RENESAS TECHNICAL UPDATE

Product Category	MPU&MCU		Document No.	TN-SH7-A535A/E	Rev.	1.0
Title	SH7705 Product code change due to IrDA bug fixing		Information Category	Technical Notification		
Applicable Product	HD6417705	Lot No.	Reference Document	SH7705 Group Hardware Manual (REJ09B0082-0200O Rev. 2.00)		
		All

3.1 LQFP208 Package

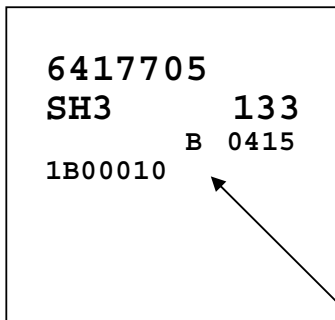
(2) New mask (B mask)

B will be added
